PCN – Product Change Notification

Document No	PCN-A-090228	Revision	1.0		
-------------	--------------	----------	-----	--	--

PCN Topic: New 9 inches Open Frame Dimension_ W09L100-OFM1

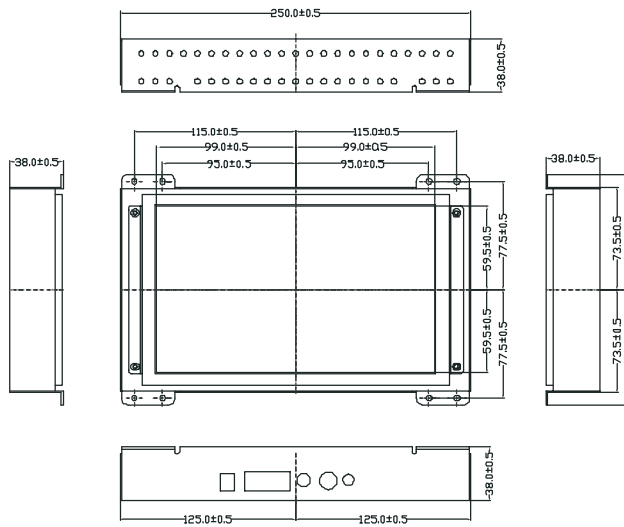
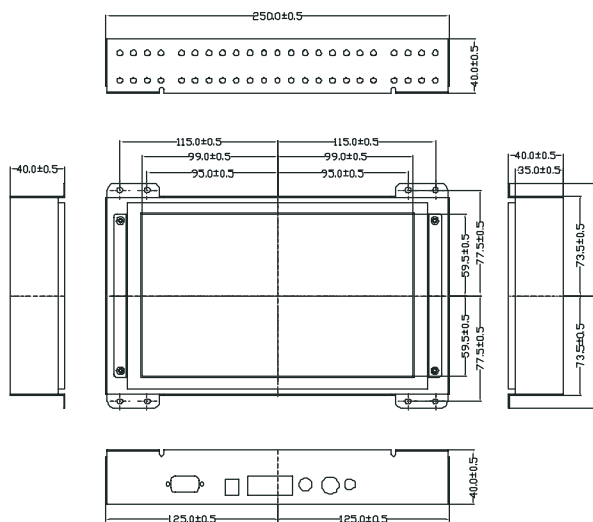
The dimension of mechanical will change from 250 x 165 x 38 mm to 250 x 165 x 40 mm . The below pictures show the example of how the new mechanic differ from Original one.
